MEMORANDUM FOR: RECORD

July 9, 2015

SUBJECT: DETERMINATION REGARDING THE SUITABILITY OF PROPOSED DREDGED MATERIAL FROM GEORGIA-PACIFIC GYPSUM, EVALUATED UNDER SECTION 404 OF THE CLEAN WATER ACT, FOR UNCONFINED OPEN-WATER DISPOSAL AT THE COMMENCEMENT BAY NONDISPERSIVE SITE.

Figure 4

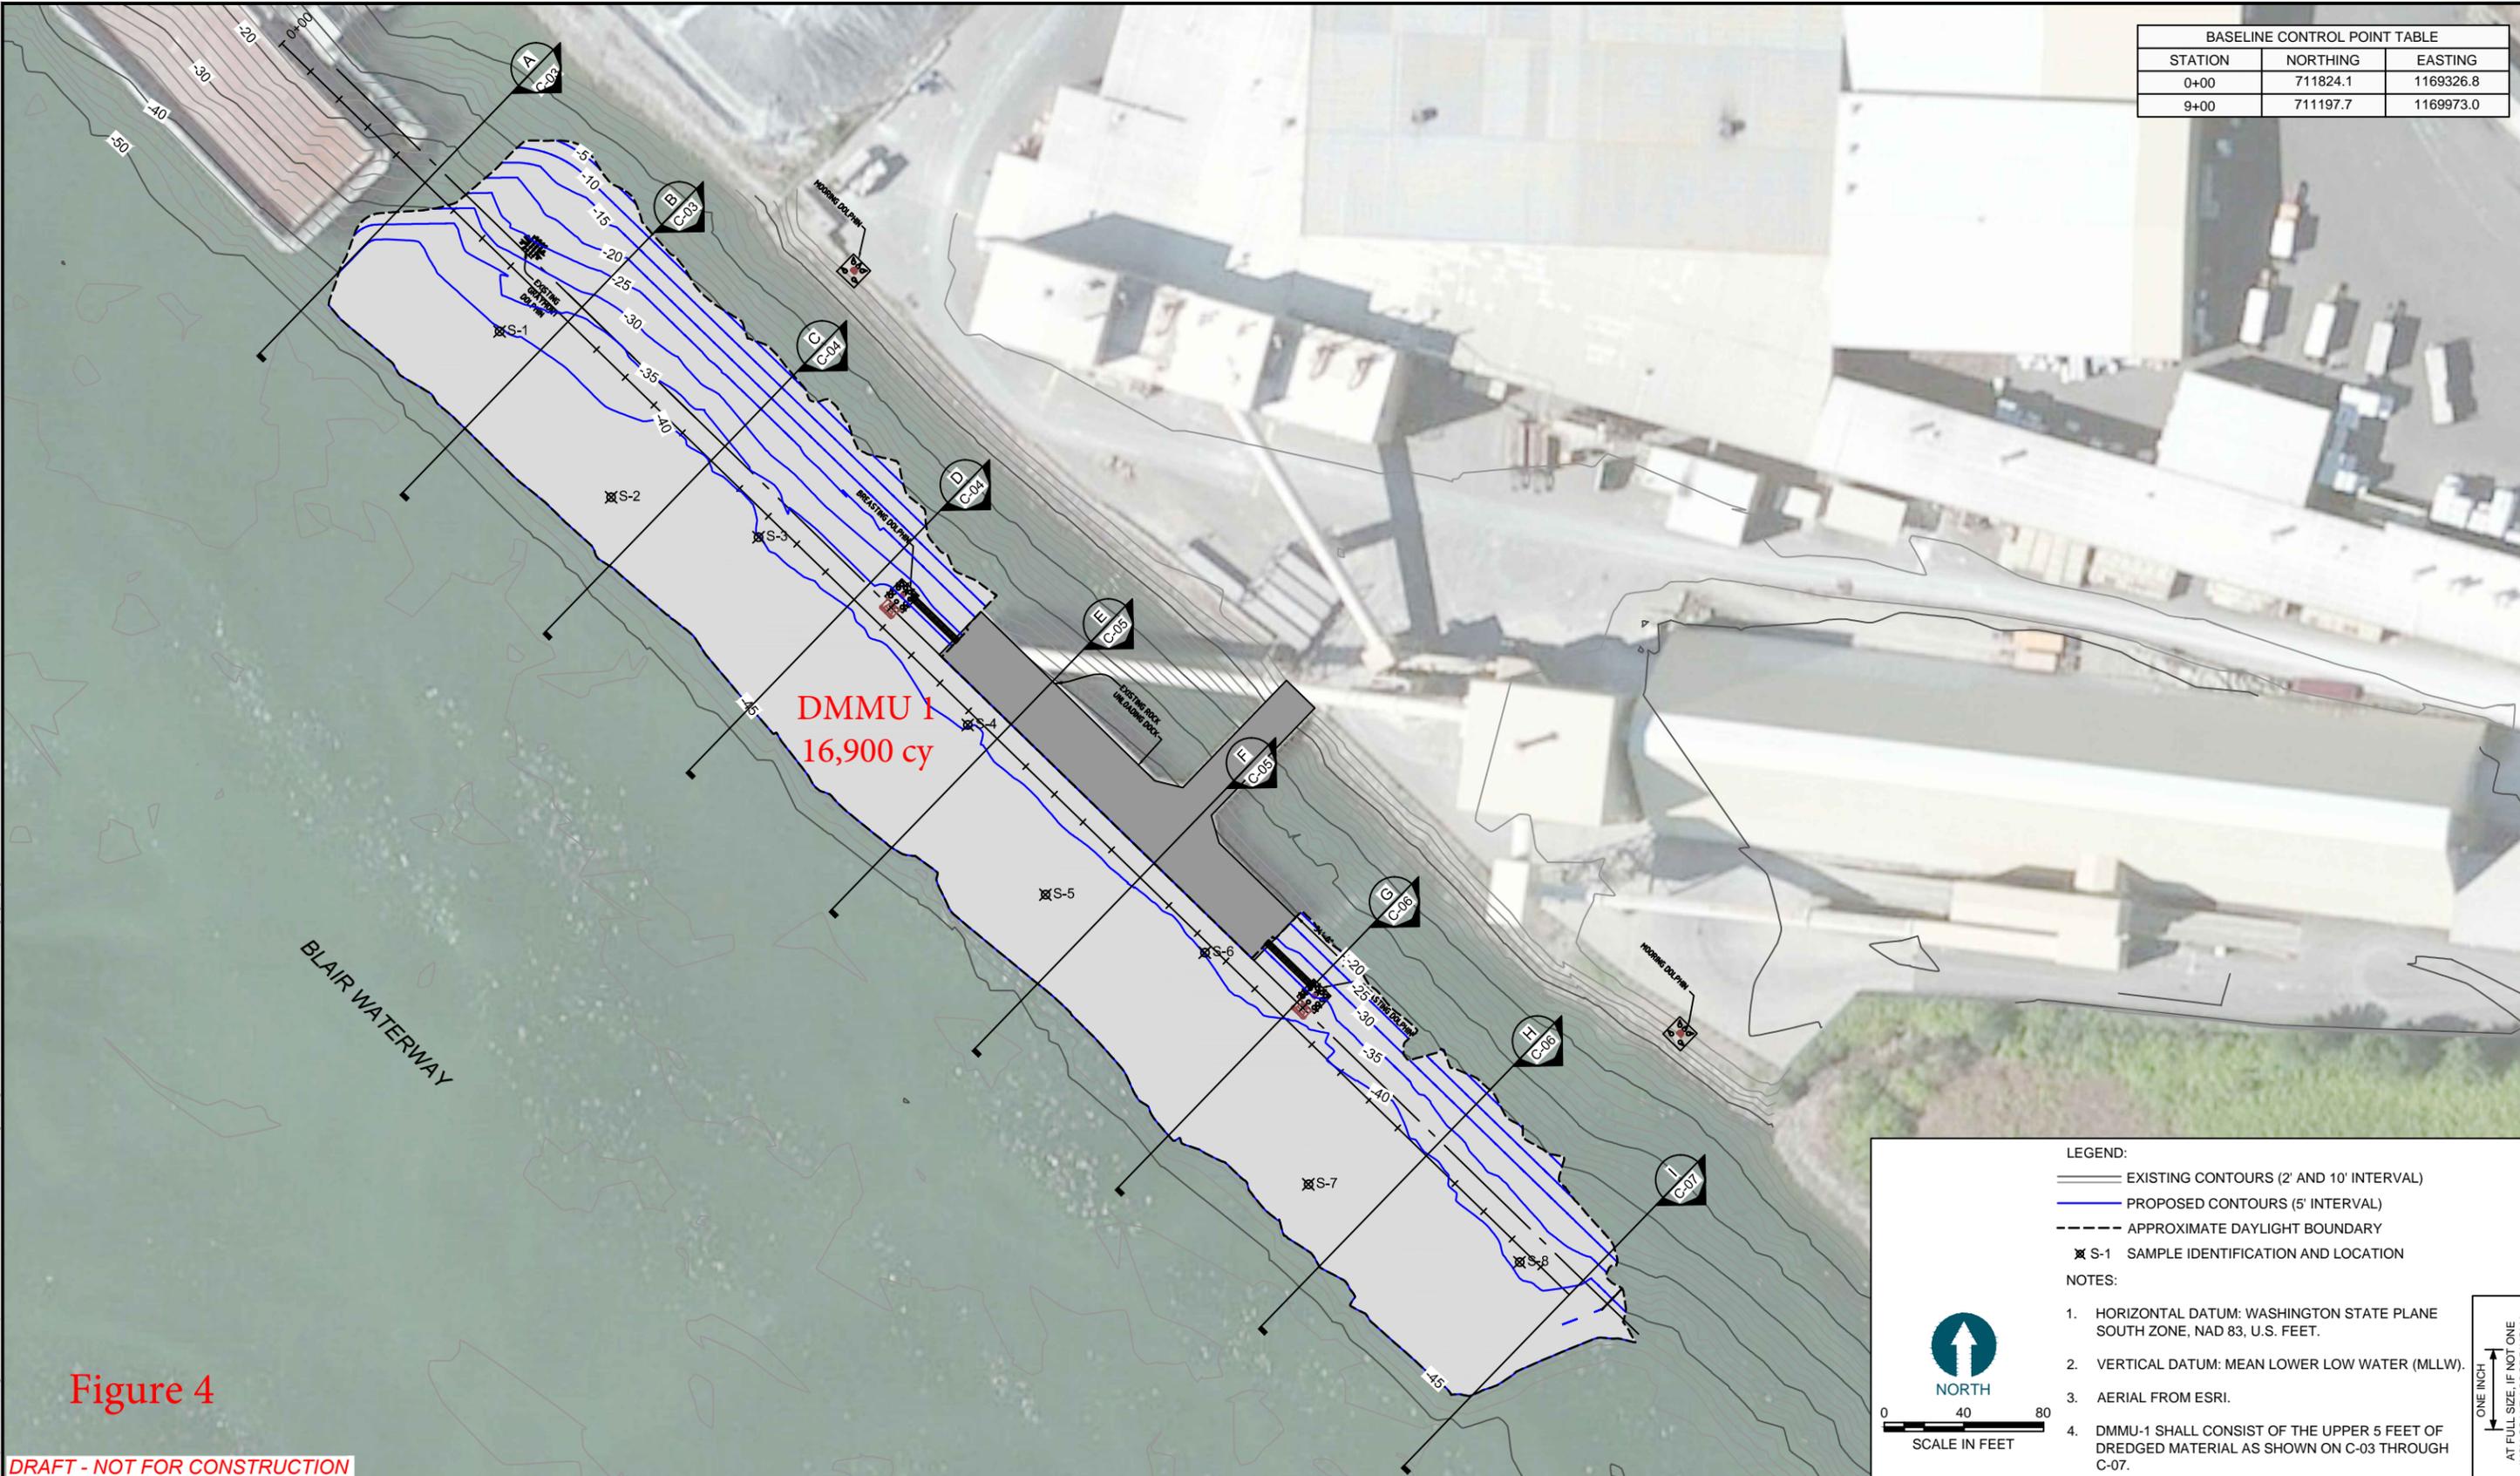
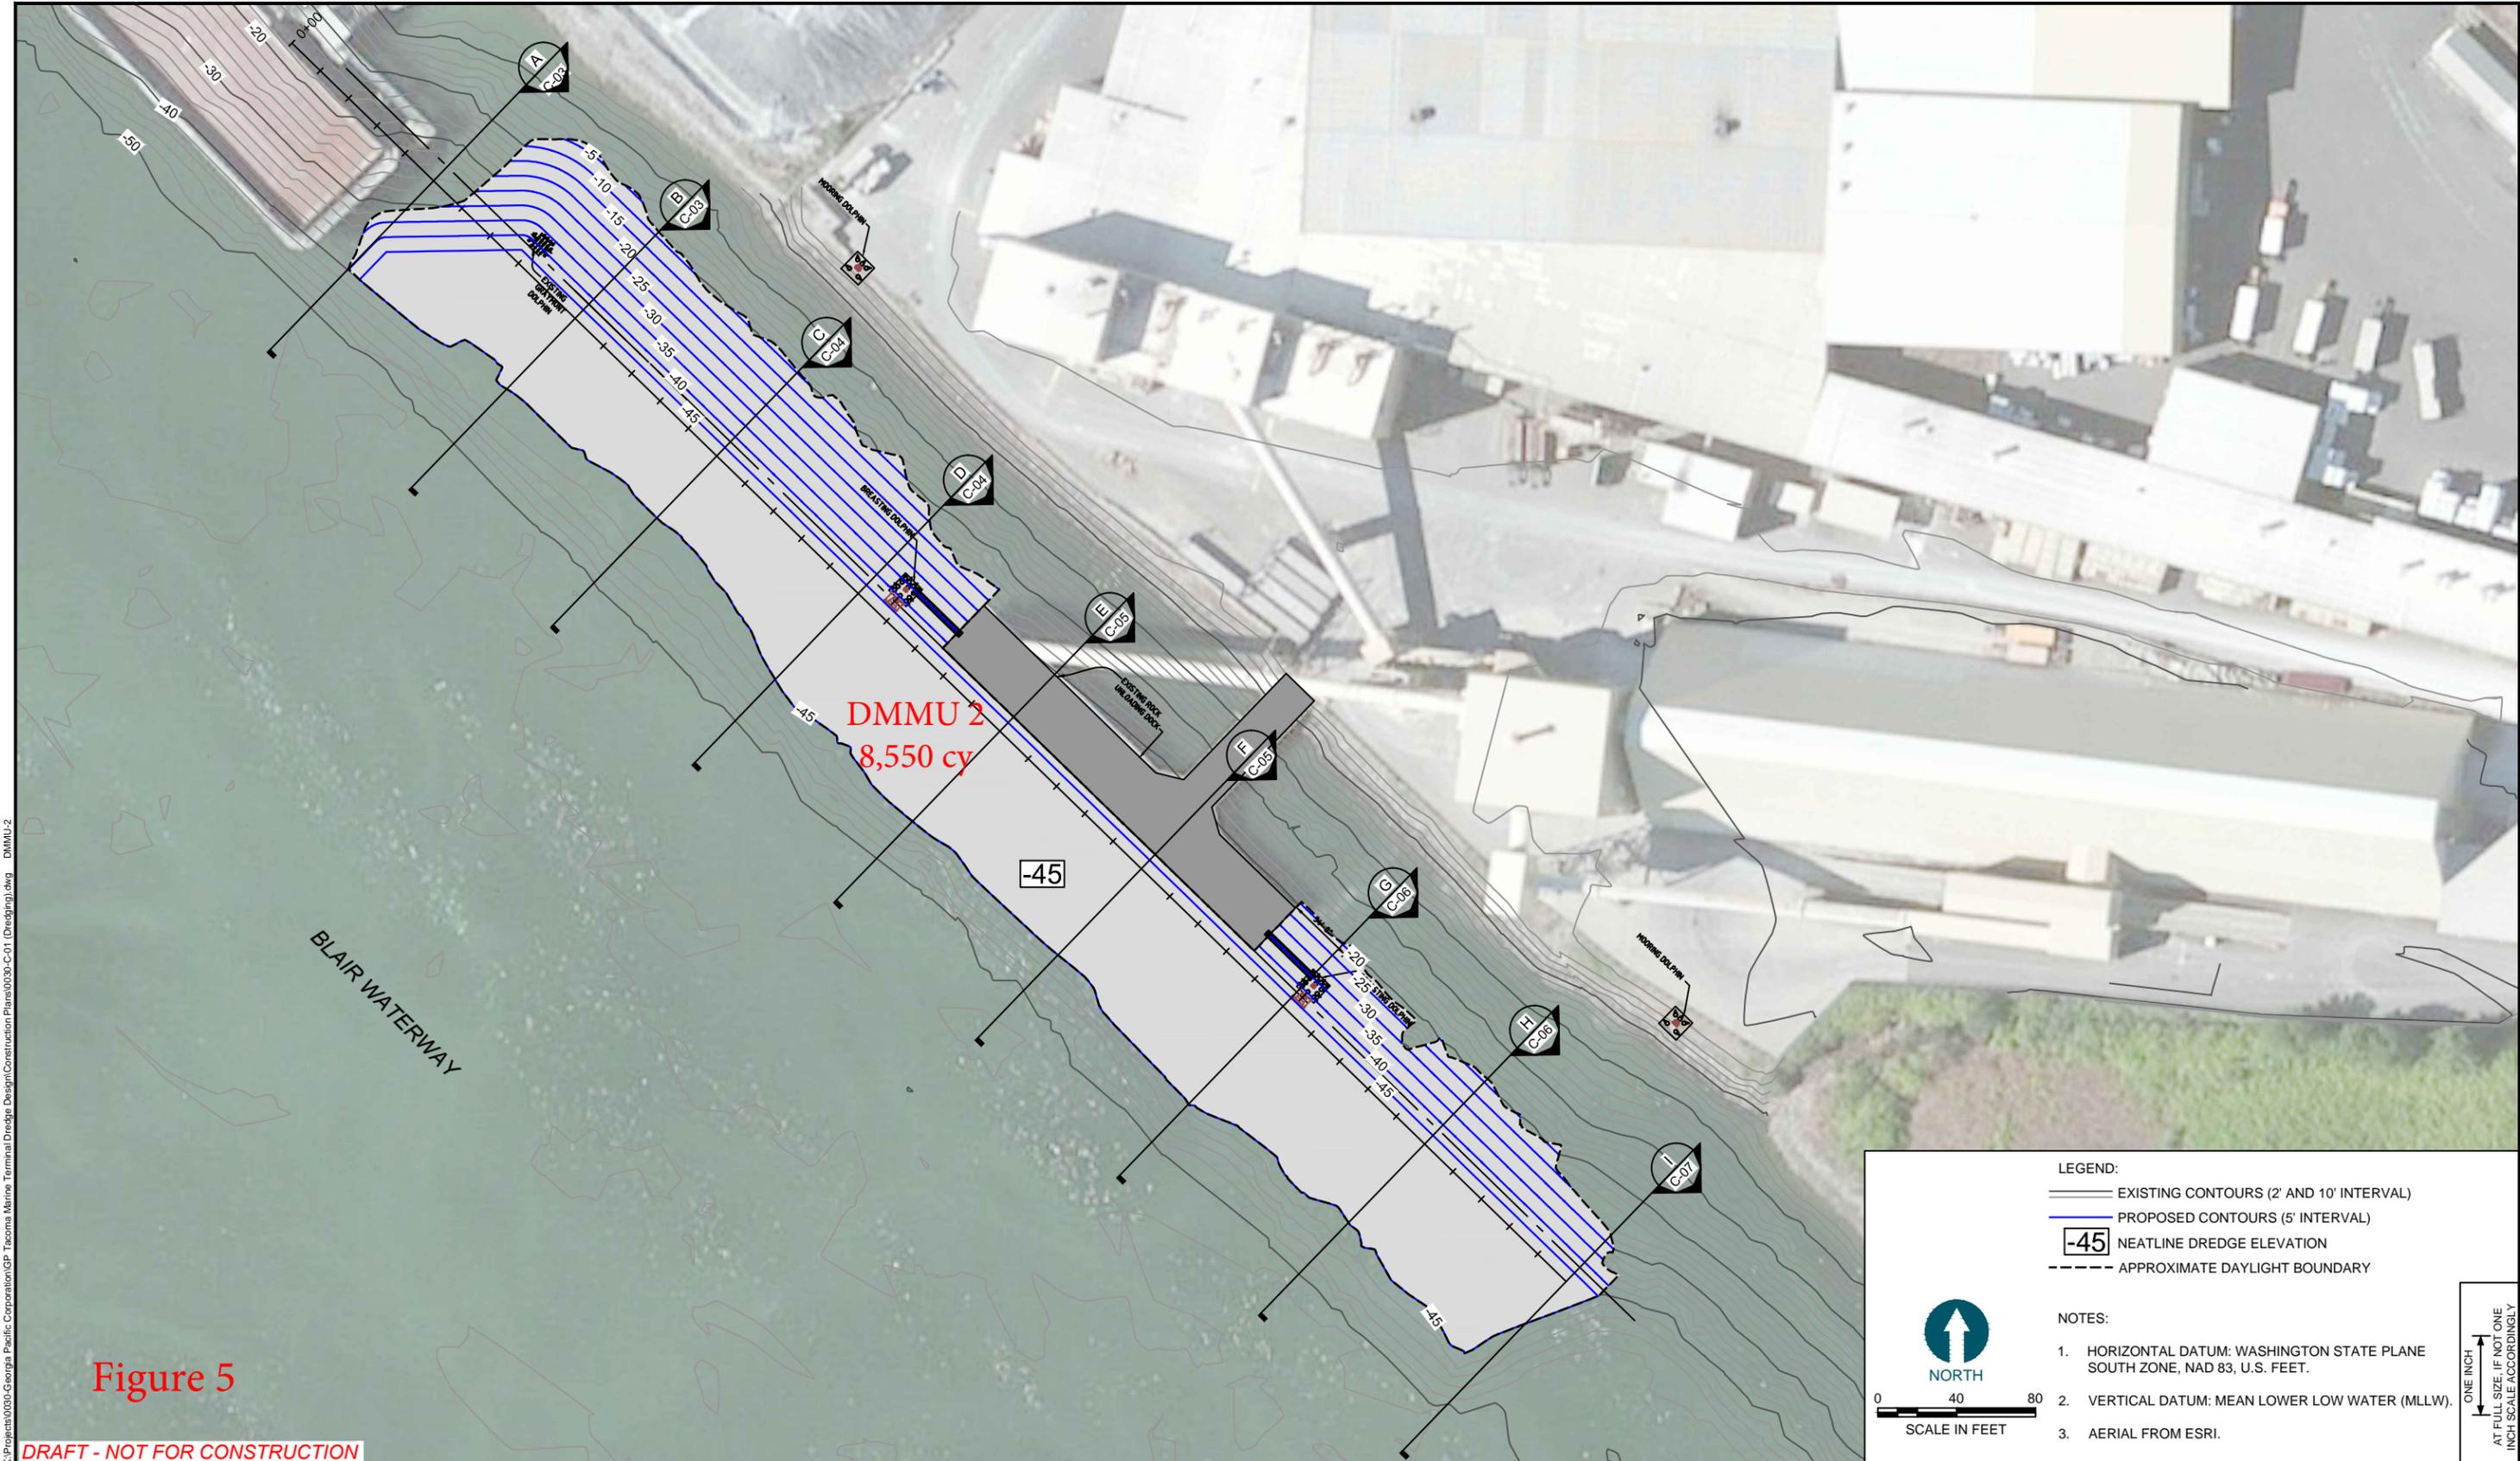
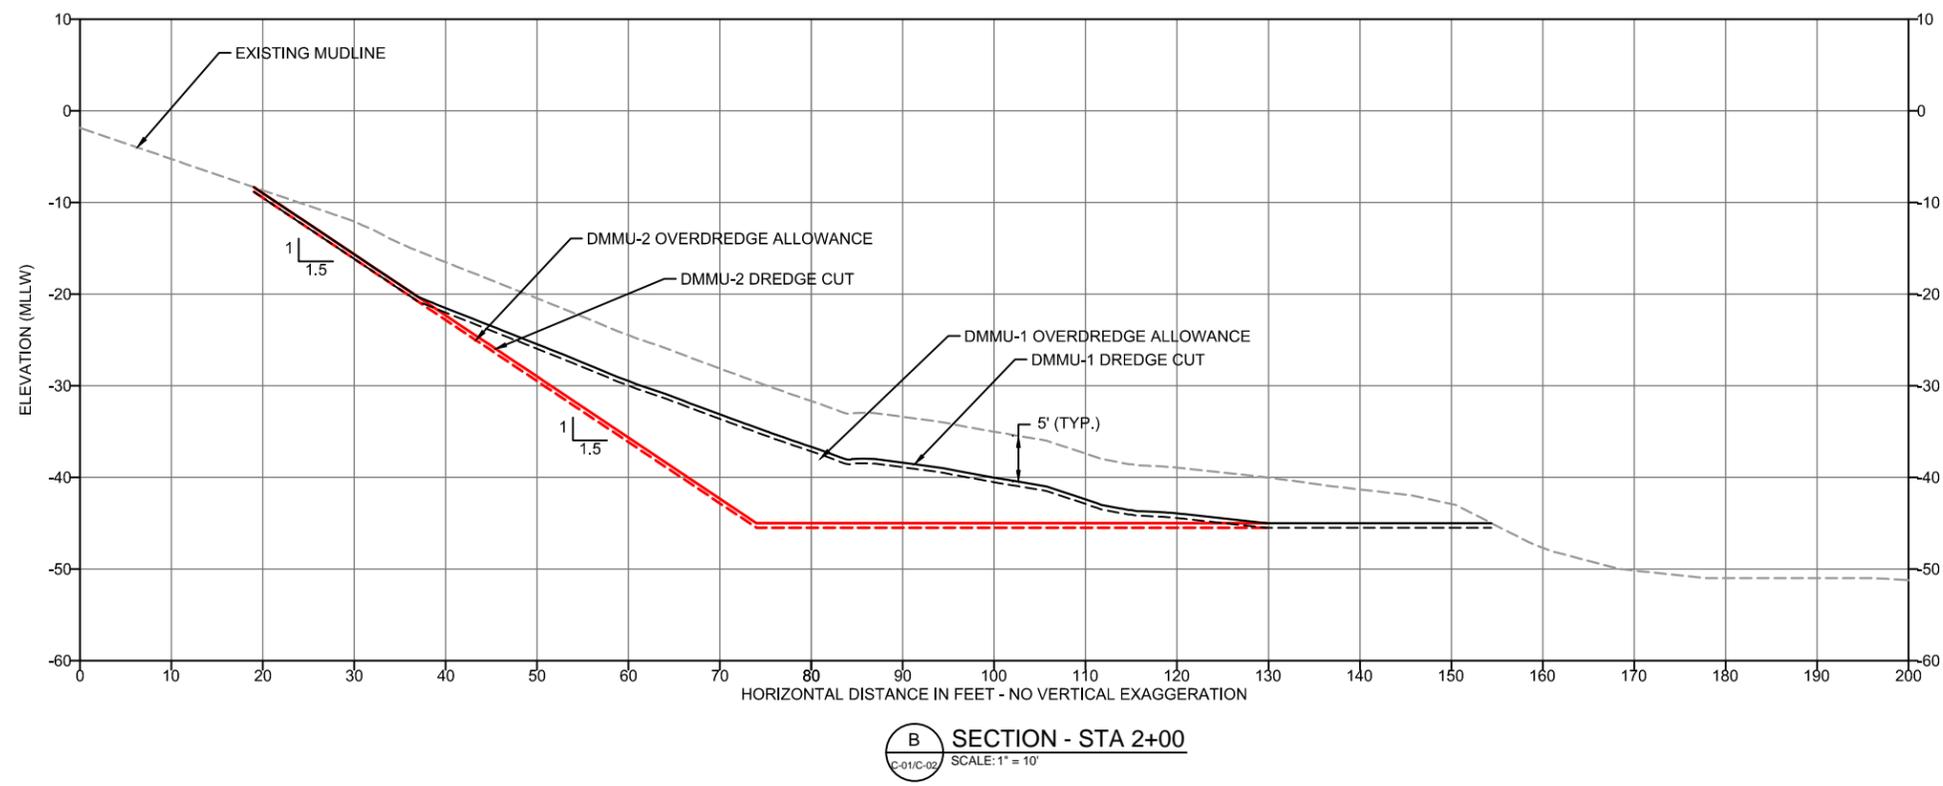
In order to adequately separate the unsuitable surface material from the suitable subsurface material during dredging, the DMMP agencies are requiring a one-foot vertical buffer be added to DMMU 1. This means that the surface five feet (not including overdepth), must be dredged and hauled to an upland disposal site. Once the surface material has been removed, the remaining sediment may be dredged and placed at the Commencement Bay open-water disposal site.

GPG has submitted a preliminary dredge design (Figures 4 to 10) that includes the one-foot buffer. The dredge prism also includes other changes from what was presented in the SAP. In order to minimize potential impacts to Graymont Incorporated's dock to the northwest, the northern extent of the dredge prism was reduced. In addition, the overall dredge depth was changed to -45.5 ft from the depth of -45.0 ft included in the SAP. The design depth is now -45.0 ft plus a 0.5 ft overdredge allowance.

The modifications made to the dredge plan resulted in an overall reduction in the total volume from 28,710 cy to 25,450 cy. Due to the addition of the one-foot buffer, the volume of DMMU 1 increased from 14,330 to 16,900 cy. The subsurface volume included in DMMU 2 shrank to 8,550 cy.

In summary, based on the results of the previously described testing, the DMMP agencies concluded that the **16,900 cubic yards of dredged material in DMMU 1 are unsuitable for open-water disposal, while the 8,550 cy in DMMU 2 are suitable for open-water disposal at the Commencement Bay non-dispersive site.**
